ERRATA 1

Figure A.1—Calculation Flow Diagram

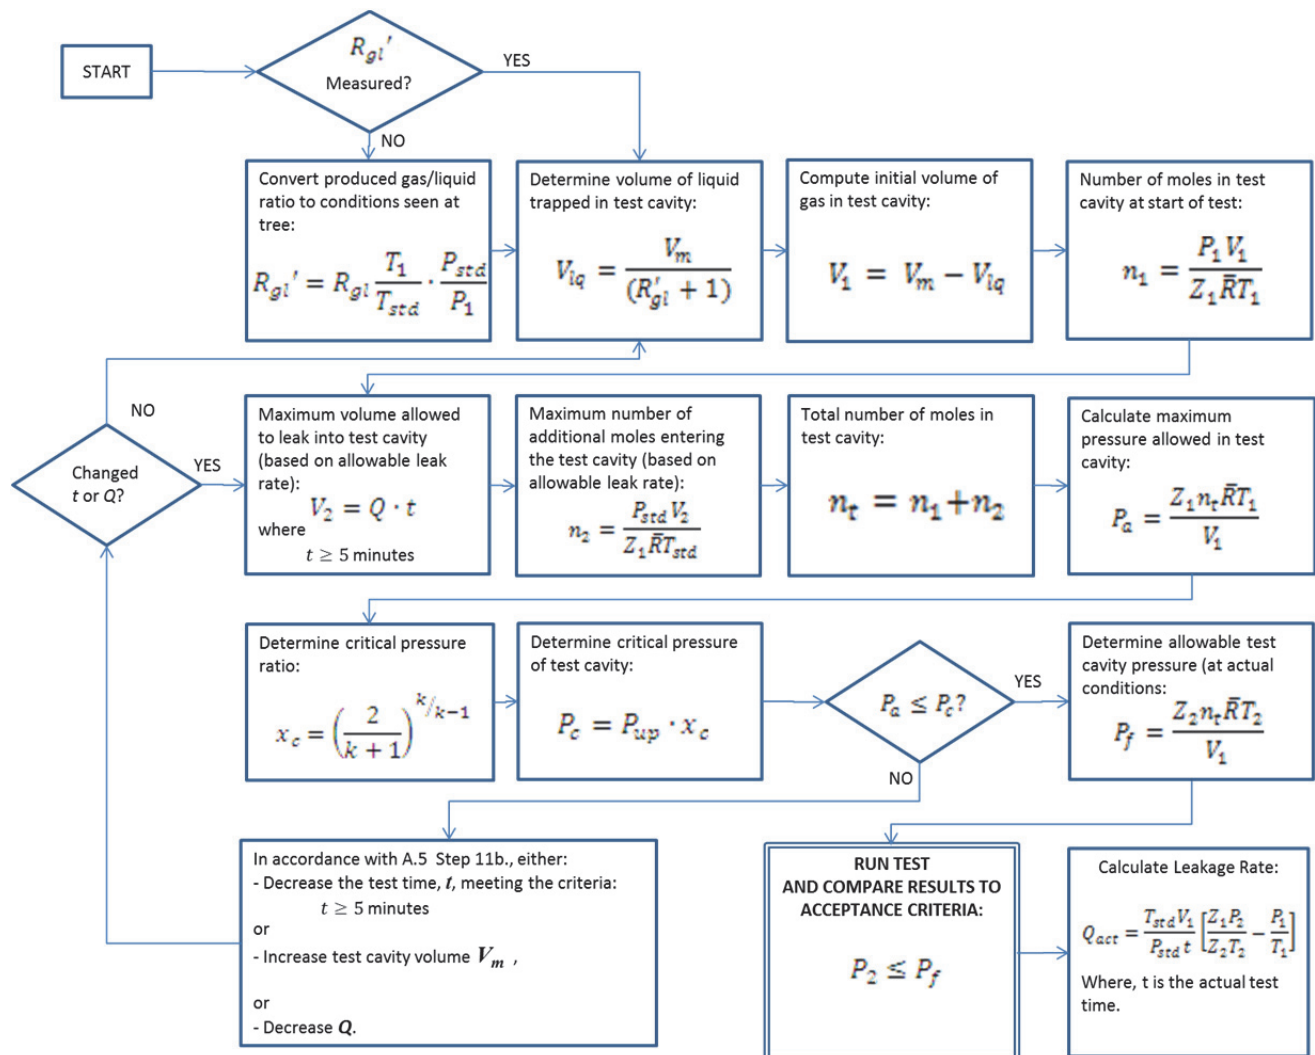
Page 19, **Figure A.1**, replace with:
